PUBLIC UTILITIES COMMISSION OF THE STATE OF CALIFORNIA

RESOLUTION SU-10
January 21, 1992

RESOLUTION SU-10, ORDER AUTHORIZING RULE CHANGES
TO GENERAL ORDER NO. 95 (G.O. 95),
RULES FOR OVERHEAD ELECTRIC LINE CONSTRUCTION

Fig. 56-10.

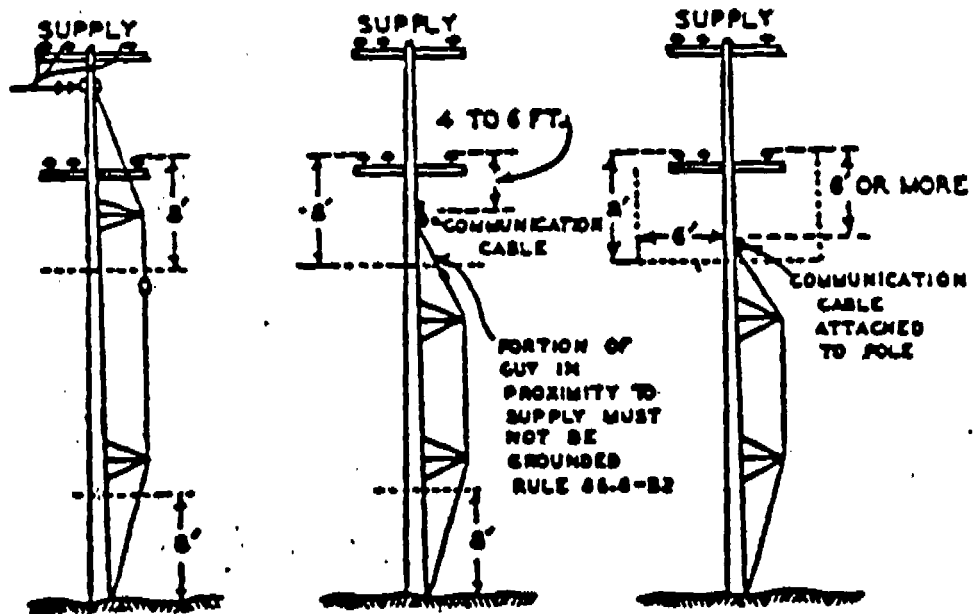
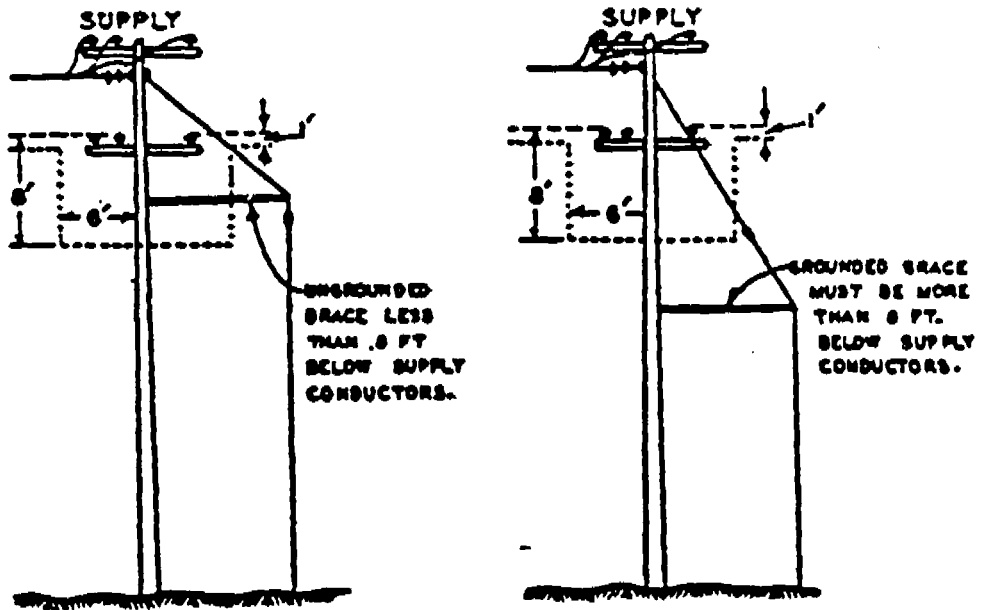
The proposed rule change is to simplify and clarify the present language with minor changes in syntax. Also, relocate related figure for Appendix G to the text opposite the rule number and change to current numbering sequence (Fig. 56-10).

An insulator shall be installed in each truss guy which is required to be sectionalized by Rule 56.6-A, so that such insulator is located 8 feet or more above the ground and 8 feet or more below the level of the lowest supply conductor passing within 8 feet of the guy (see Fig. 56-10). These requirements can normally be met by insulation at one position; however, in certain unusual conditions the two 8-foot distances may overlap, in which case insulation will be necessary at two positions.

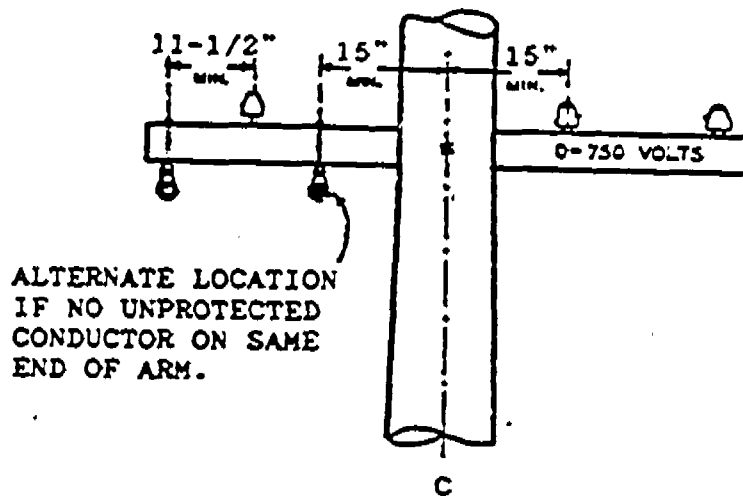
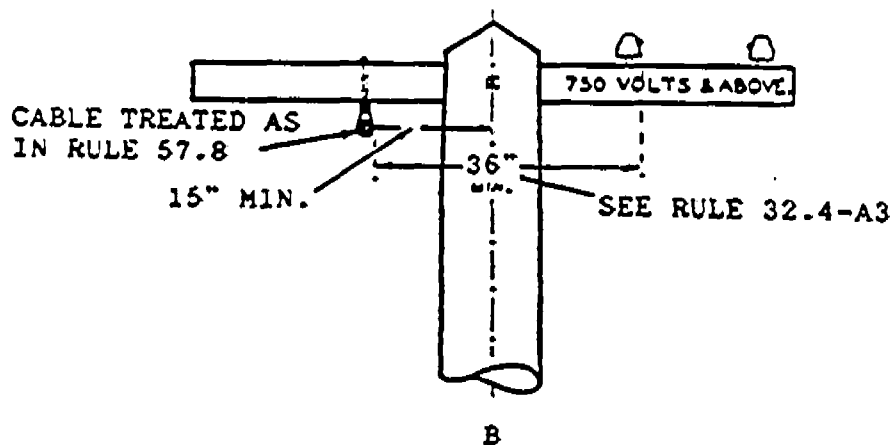
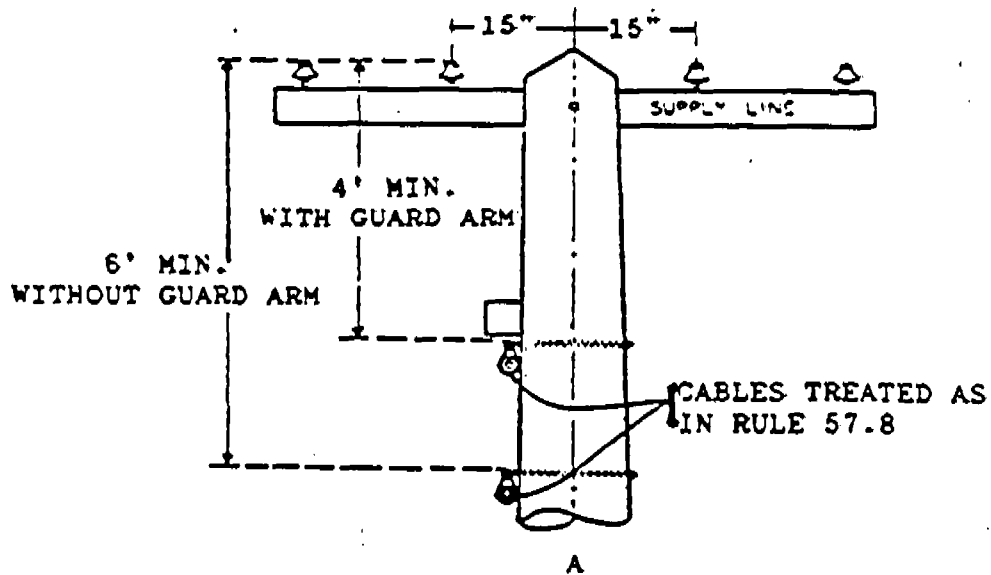
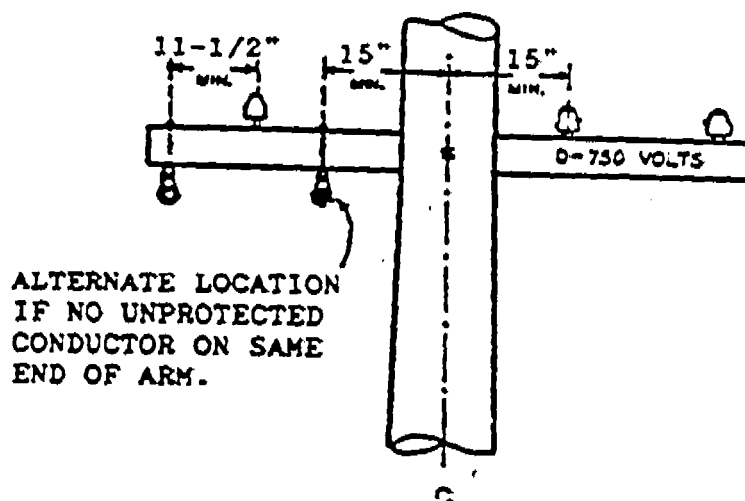
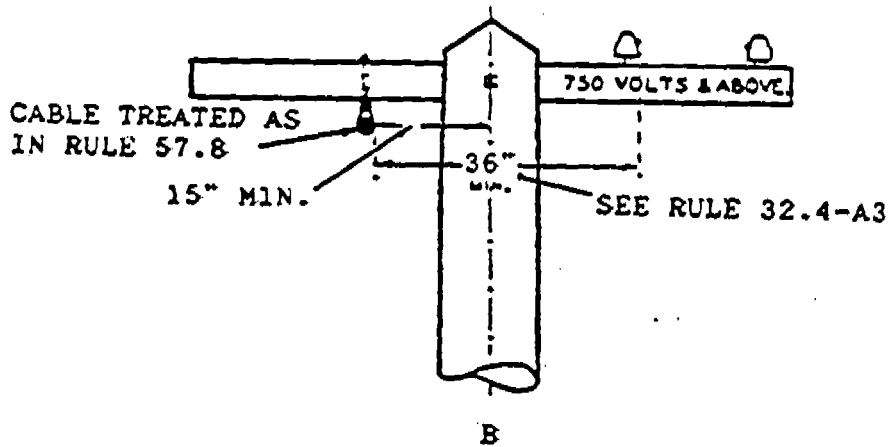
(1) Attached to Surfaces of Poles and Crossarms: Such grounded messengers and cables may be attached to the surfaces of poles or wood crossarms at less than the clearance specified in Table 1, Column D, Cases 8 and 9. When attached to pole or wood crossarm at less than 15 inches from center line of pole such grounded messenger or cable shall ~~be not~~ not be less than 4 feet vertically above or 6 feet vertically below any unprotected supply conductor except that where a guard arm (or arms) is placed above messenger and cable as specified in Rule 57.7, the clearance of 6 feet may be reduced to not less than 4 feet below unprotected conductors of 0-750 volts ~~(see-App-67-Fig-53)~~ (see Fig. 57-1 A).

(2) Supported on Same Crossarm Above 750 Volts: Such grounded messenger and cable when supported on the same crossarm with unprotected conductors in excess of 750 volts shall be placed on the side of pole opposite the unprotected conductors ~~(see-App-67-Fig-54)~~ (see Fig. 57-1 B).

(1) Attached to Surfaces of Poles and Crossarms: Such grounded messengers and cables may be attached to the surfaces of poles or crossarms at less than the clearance specified in Table 1, Column D, Cases 8 and 9. When attached to pole or crossarm at less than 15 inches from center line of pole such grounded messenger or cable shall not be less than 4 feet vertically above or 6 feet vertically below any unprotected supply conductor except that where a guard arm (or arms) is placed above messenger and cable as specified in Rule 57.7, the clearance of 6 feet may be reduced to not less than 4 feet below unprotected conductors of 0-750 volts (see Fig. 57-1 A).

(2) Supported on Same Crossarm Above 750 Volts: Such grounded messenger and cable when supported on the same crossarm with unprotected conductors in excess of 750 volts shall be placed on the side of pole opposite the unprotected conductors (see Fig. 57-1 B).

Figure 92-1

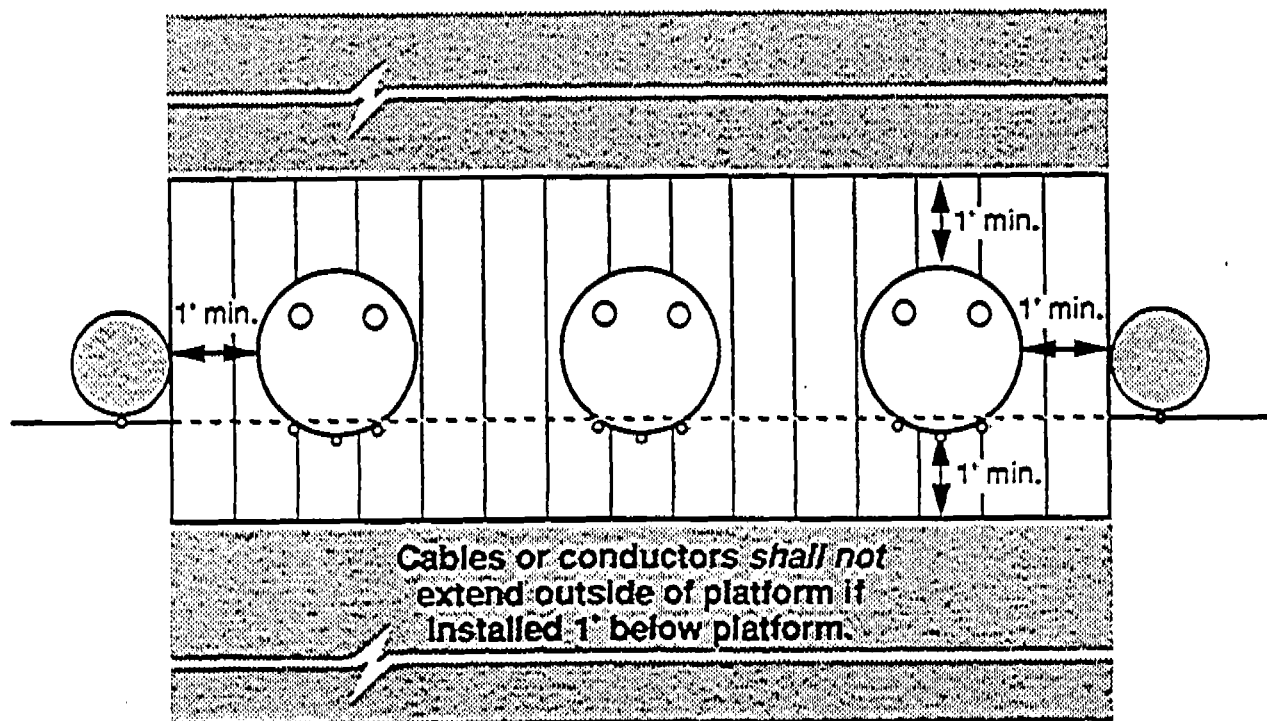
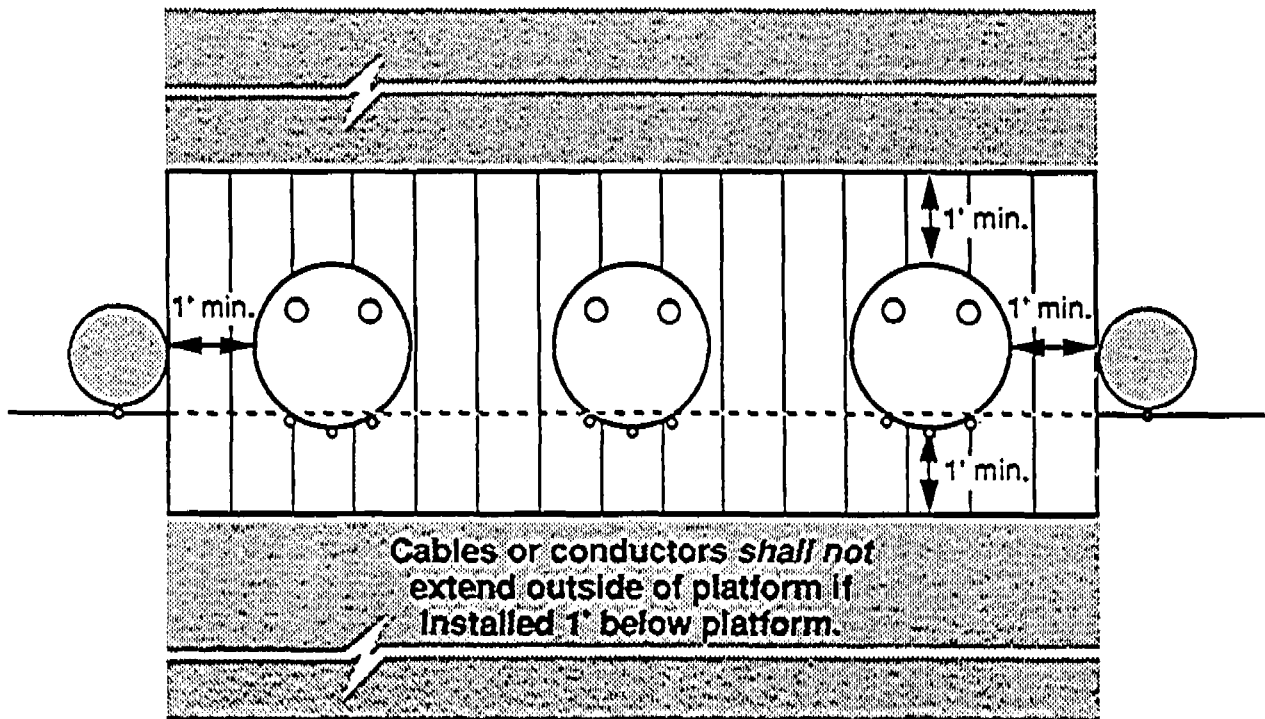
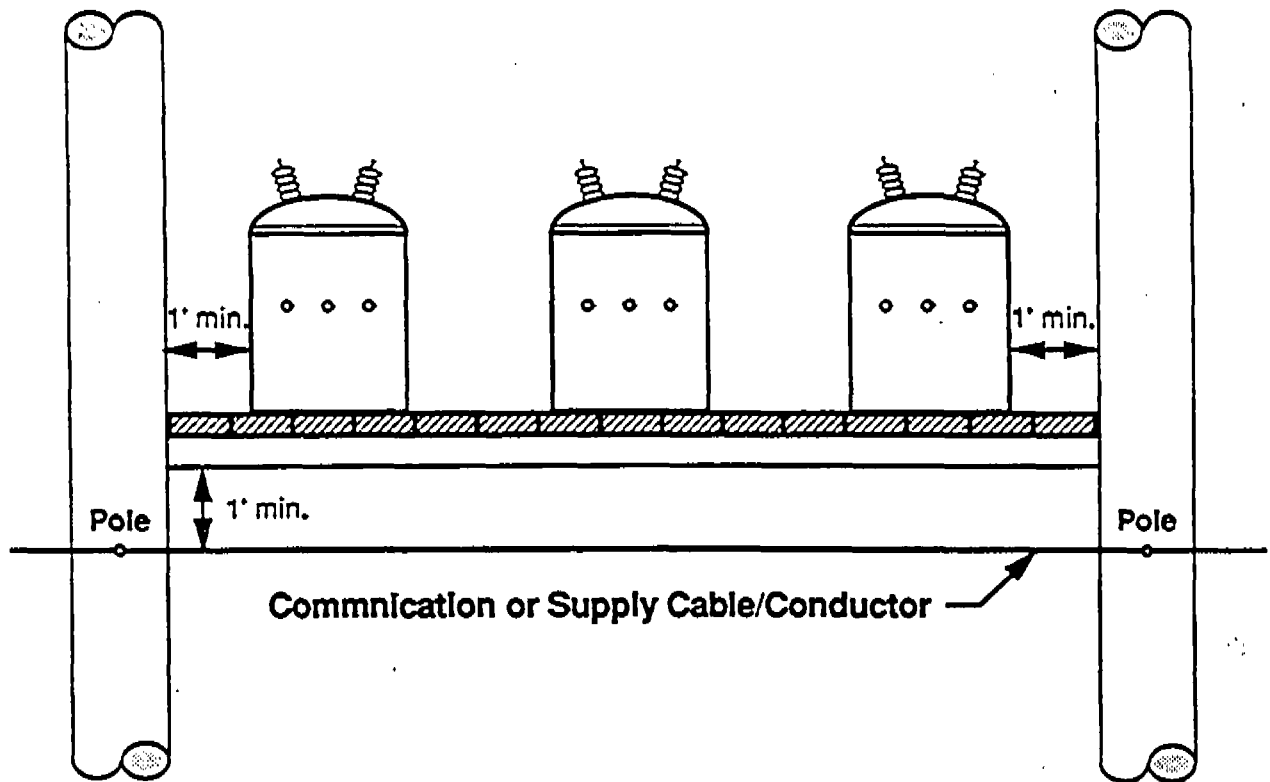
Where transformers or regulators are installed on platforms having continuous flooring which extends not less than 1 foot horizontally outside of the vertical plane of all transformers or regulator lead and bus wires on the same pole or structure, cables or other conductors may be installed at a minimum vertical distance of 12 inches below the transformer or regulator cases provided such cables or conductors do not extend laterally beyond the platform (see Fig. 92-1).

Where transformers or regulators are installed on platforms having continuous flooring which extends not less than 1 foot horizontally outside of the vertical plane of all transformers or regulator lead and bus wires on the same pole or structure, cables or other conductors may be installed at a minimum vertical distance of 12 inches below the transformer or regulator cases provided such cables or conductors do not extend laterally beyond the platform (see Fig. 92-1).
